STATEMENT OF ENVIRONMENTAL EFFECTS TO CANTERBURY-BANKSTOWN CITY COUNCIL

PROPOSED DEMOLITION OF EXISTING STRUCTURES & CONSTRUCTION OF A SHOPTOP
HOUSING DEVELOPMENT

**SECTION 4.55 (1a) – MINOR CHANGES REGARDING FIRE SAFETY, RELOCATION OF OSD
AND REMOVAL OF NON-APPLICABLE CONDITIONS IN DA 994/2021 REGARDING WASTE
MANAGEMENT ISSUES**

AT 352 KING GEORGES RD, BEVERLY HILLS NSW 2209

Figure 7-1: Indicative fire wall markup – Ground floor. Note: fire wall and fire rating markup may be indicative, and the building shall meet NCC DtS and certifier's requirements for fire rating in the DtS areas

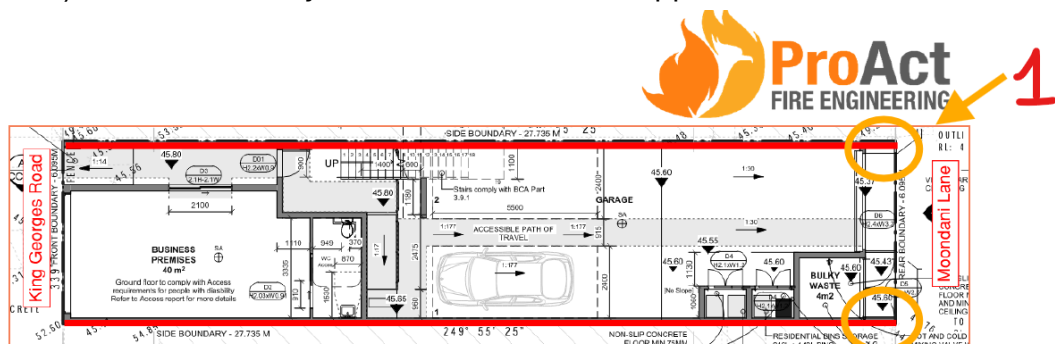
1. Extension of side walls to protect windows/doors that are within 3m of side boundary

The Fire Engineer identified a few doors and windows that are within 3m of the side boundaries and are at risk of spreading fire. The engineer proposed extension of side walls to protect these doors & windows with details as below

- Ground Floor - Extension by **1m** towards Moondani Lane (Note 1 in figure 8)
- First floor - Extension by **1.5m** towards Moondani Ln (Note 2 in figure 8). The side walls at the front (facing King Georges Rd) are already approved by Council in DA.
- Second Floor - Extension by **0.3m** at the front and **1.5m** at the back (Note 3 in figure 8). The front already has side walls of 1.2m approved.

Figure 10 – Structural Plan – Footing and Piling Plan (Submitted with this S4.55)

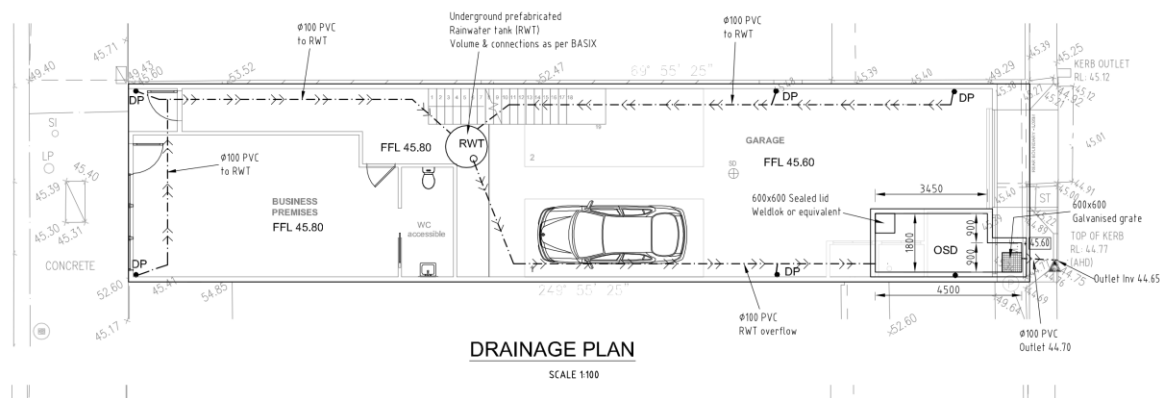
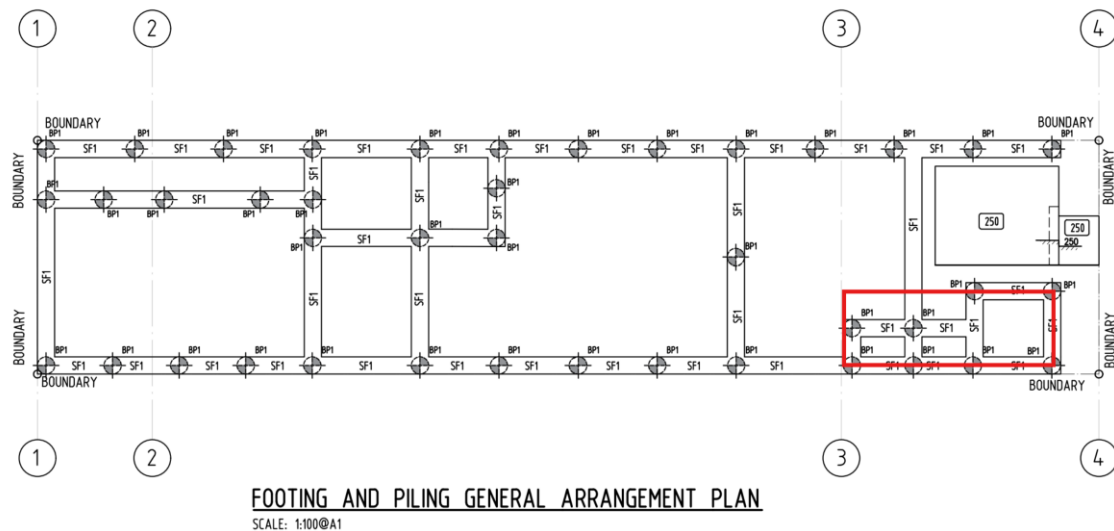
The approved location of the OSD is too close to the boundary and will affect the building's foundation and stability of adjacent building.

The proposed OSD position is not feasible, it is too close to adjacent property and will interfere with piles and footing beams.

Structural constraint is a constraint that shall be taken seriously. If we try to construct an OSD tank near the boundary, it will trigger the need for shoring on the walls and thick transfer slabs (top of OSD), which will lead to a dead end.

Our solution is to relocate the OSD to the middle of the driveway. By doing it, the OSD won't be interfering with the structural piles & footing beams.

- 2.4x4.5m OSD tank which can reduce the OSD water level to 460mm.
- OSD top slab can have a fall to accommodate driveway slope.
- The top of OSD can become $44.7 + 0.46 + 0.2(\text{slab}) = 45.36$

Figure 11 - Ground floor - 352 King Georges Rd, Beverly Hills

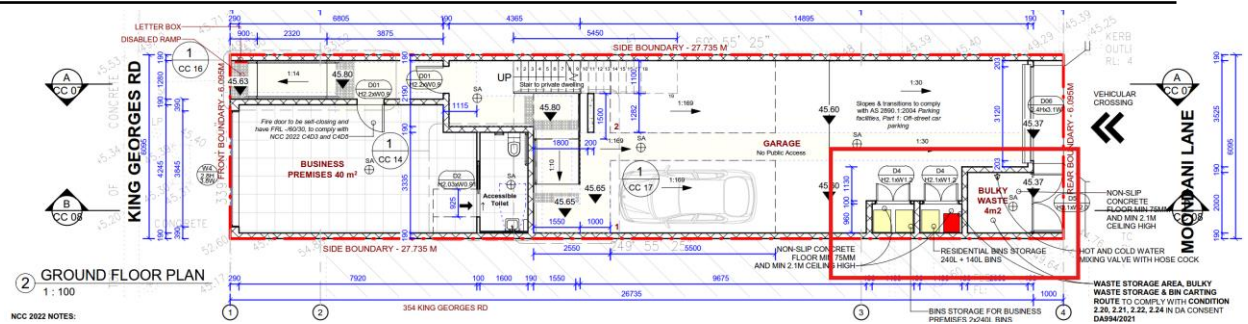
Condition 2.20 - Waste storage area – *k. Any doorways must be 2m wide*

The current arrangement that we have has 2 separate rooms for residential (1x140L and 1x240L) and commercial use (2x240L)

- Room size 1400x960mm
- Door size - 1200mm width. **A doorway of 2m for each room will not fit the rooms.**

This condition is applicable for development of larger scale such as multi-residential or residential flat building. But this one is much smaller compared to these types of development. Therefore, we'd like to request Council to remove this Condition 2.20 (k) from DA Consent. The issue was raised to Council's attention in February and got the support from Council's Engineer in May 2025. (*All correspondence is submitted with this S4.55*)

Figure 12- Ground floor - 178 Beamish St, Campsie - Door 1.2m and 1.7m

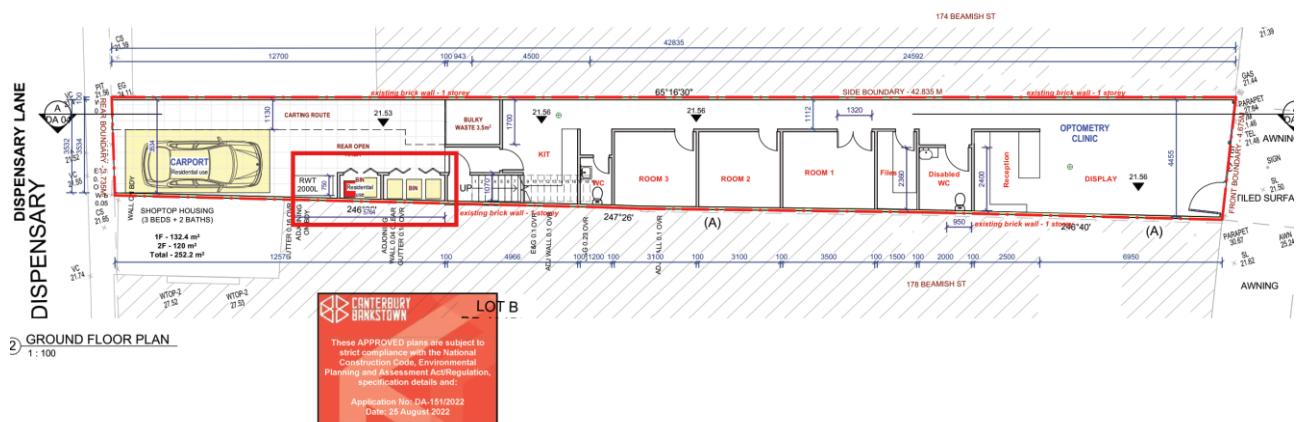
The Applicant believes this layout fits the scale of this development (*Small business premises without public access, and private dwelling*), and is accepted in few developments we did with Canterbury-Bankstown Council.
